**Federal Highway  
Administration**

February 8, 2008

In Reply Refer To: HSSD/B-168

Thank you for your letter of September 6, 2007, requesting the Federal Highway Administration's (FHWA) acceptance of a Massachusetts Highway Department (MHD) modification to the Minnesota Type Three Combination Bridge Rail. You requested that we find this barrier acceptable for use on the National Highway System (NHS) under the provisions of the National Cooperative Highway Research Program (NCHRP) Report 350 "Recommended Procedures for the Safety Performance Evaluation of Highway Features." Crashworthiness of the Test Level 3 (TL-3) barrier, intended for use on the Annisquam River Bridge, was evaluated using finite element modeling.

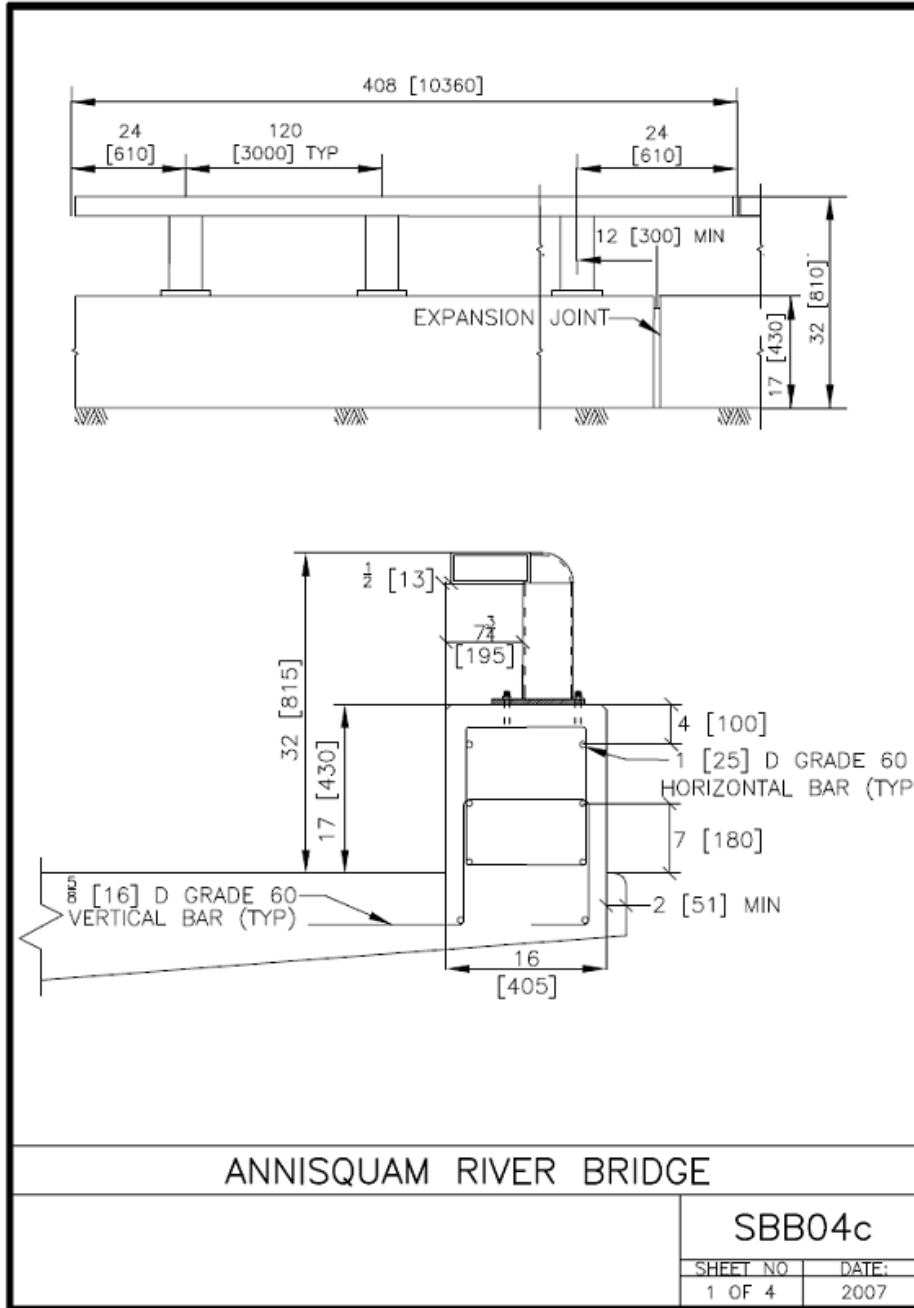
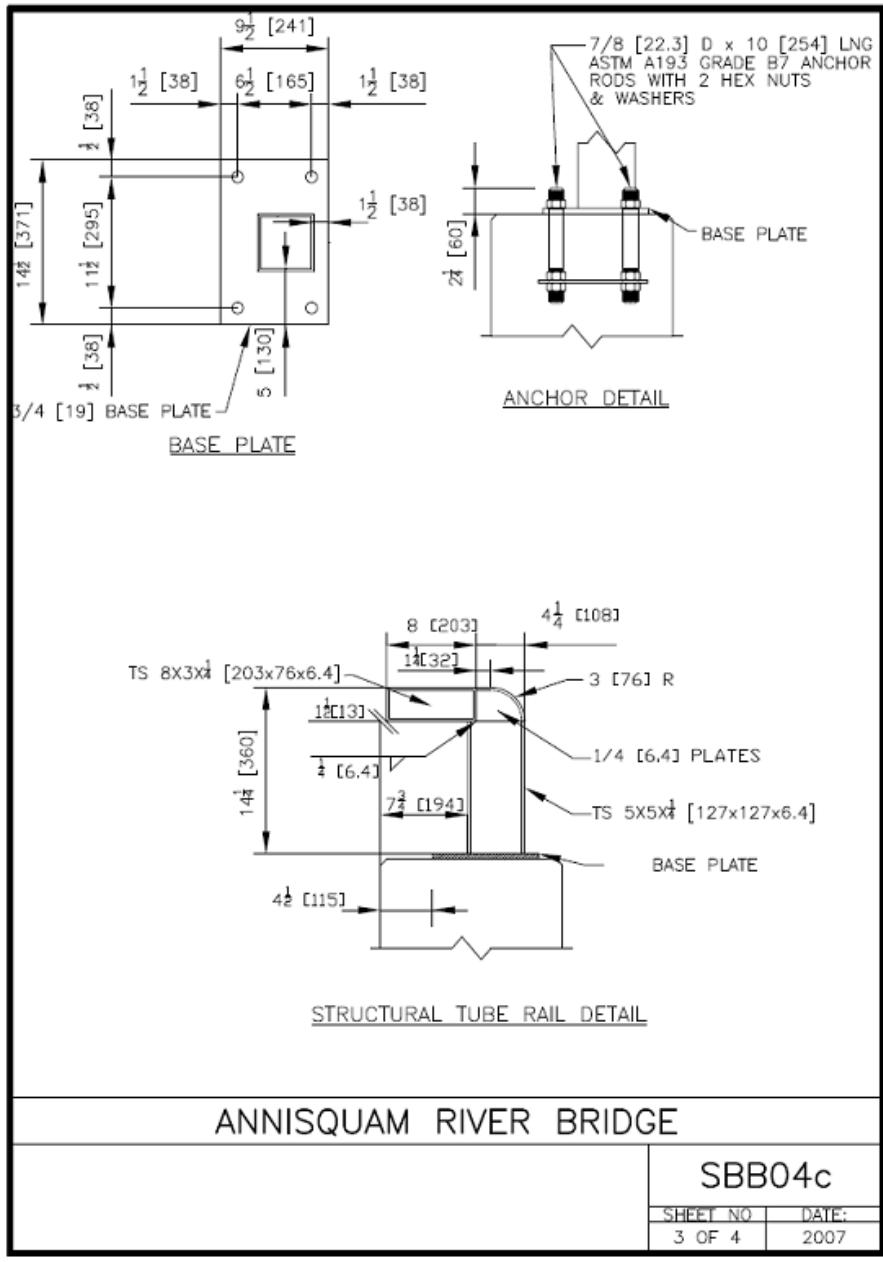
The 35-inch tall Minnesota railing was tested to NCHRP Report 350 TL-4 and accepted by the FHWA in our memorandum "Crash Testing of Bridge Railings" dated May 30, 1997. The 32-inch tall Annisquam/MHD version (shown in the enclosed drawings) varies from the tested railing in a number of dimensions including overall height, height of concrete parapet, and details of the post and rail. The dimensions and test results of the Minnesota TL-4 rail, and the six different Annisquam Bridge railing proposals that were evaluated with finite element analysis (FEA) for TL-3, are detailed in "Table 17", enclosed for reference.

Current FHWA policy does not allow the substitution of computer modeling for the NCHRP Report 350 crash test evaluation of new devices. However, we have considered the results of FEA when evaluating modified devices that had already been evaluated and accepted using full scale crash testing. Because the requested modifications retain the significant structural details of the Minnesota design, and the requested railing is comparable to other crash tested concrete-parapet-and-steel-rail designs, we concur in your assessment.

The bridge rail system described above and detailed in the enclosed drawings is acceptable for use on the NHS under the NCHRP Report 350 Test Level 3 conditions tested, when proposed by a highway agency.
